TO: Mercedes-Benz Dealer Principals, General Managers, Sales Managers, Service Managers, Parts Managers	FROM: Gregory Gunther, Senior Manager, Vehicle Compliance and Analysis, Engineering Services
RE: Service Campaign Launch Notification Update Battery Management System Control Unit Software MY23-24 EQE Sedan, and EQS Sedan, EQS SUV (295, 296, and 297 platform)	DATE: August 30, 2024

Service Campaign Bulletin

Campaign No. 2024020009, August 2024

Update Battery Management System (BMS) Control Unit Software

Figure 1

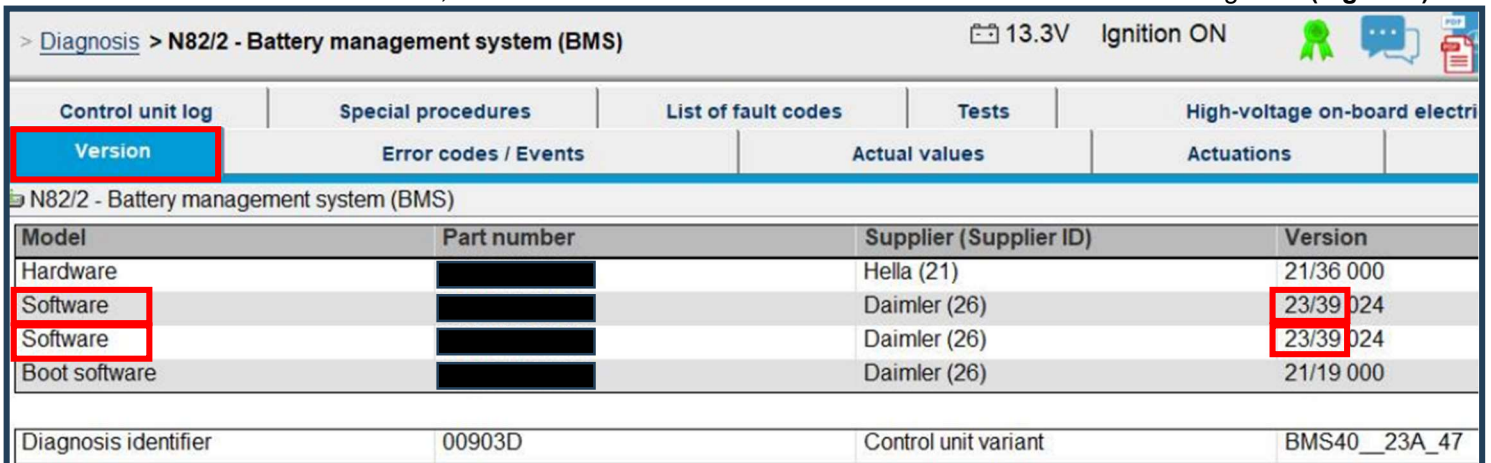
1. Connect XENTRY Diagnosis.
2. Update **Battery Management System (BMS) control unit** software.
 - i** To do this, select menu item "Quick test view → **N82/2 – Battery management system (BMS)** → Adaptations → Control unit update → Updating of control unit software".
 - i** Then follow the user guidance in XENTRY Diagnosis.

NOTE: To confirm the BMS software, the Software **Version** will read "**23/XX**" or newer in XENTRY Diagnosis (**Figure 1**).
